SERVICE INFORMATION BULLETIN

APPLICABILITY: 2018-19MY Impreza

NUMBER: 05-66-18

SUBJECT: Front Suspension Crossmember Bolt Change

COMPARISON PHOTOS:

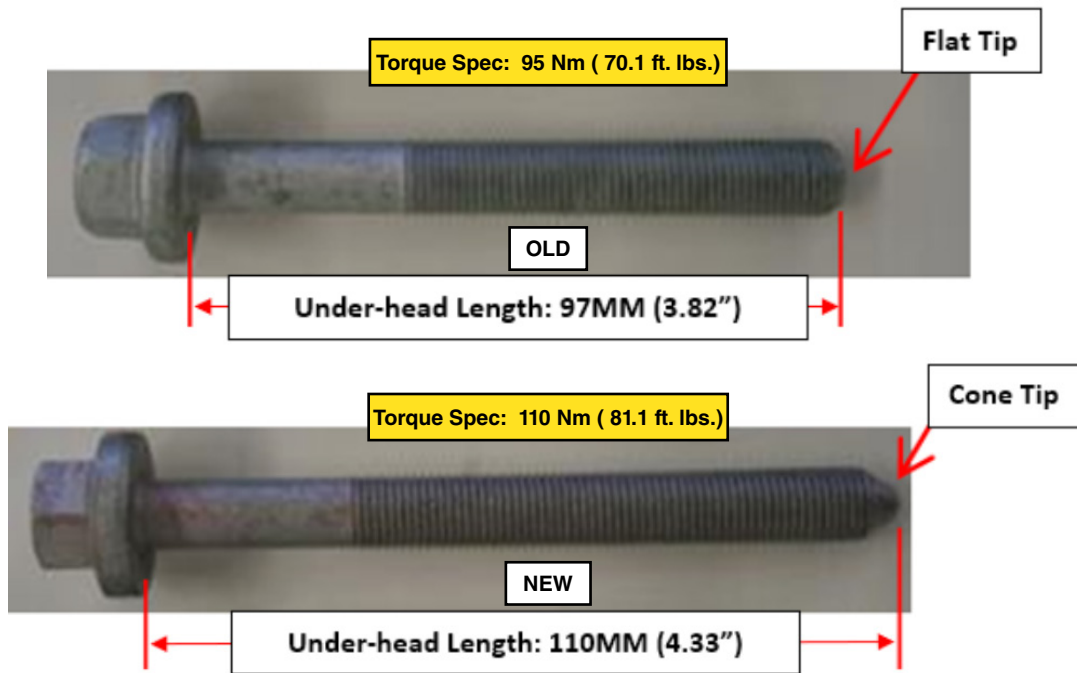
This Service Information bulletin announces a running change to the four (4) front suspension crossmember retaining bolts to improve production efficiency. The new bolts have an increased length and are easily identifiable with their “cone” shape on the threaded end.

The part number for the new bolt is **20008FL00A** (qty. 4 per vehicle).

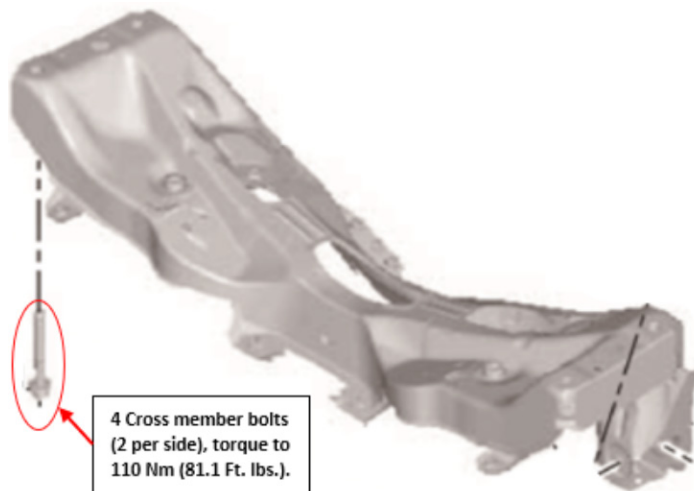
REMINDER: Customer satisfaction and retention starts with performing quality repairs. These new crossmember bolts have a **revised (HIGHER) torque specification of 110 Nm (81.1 ft. lbs.)**. Otherwise, the Service Procedure for their replacement remains unchanged. Always refer to the applicable Service Manual and review the full requirements of the repair being performed. The Service Manual procedures contain information critical to performing an effective repair the first time and every time. This includes but is not limited to: important SAFETY precautions, proper inspection criteria, necessary special tools, required processes and related one-time-use parts needed for a complete and lasting repair.

IMPORTANT: While the old design and new design bolts may be used in combination, due to the differences in torque requirements, when replacement is necessary, it is recommended to ensure all 4 bolts being used are the same type in order to eliminate having a mix of both with their different torque requirements during the installation process.
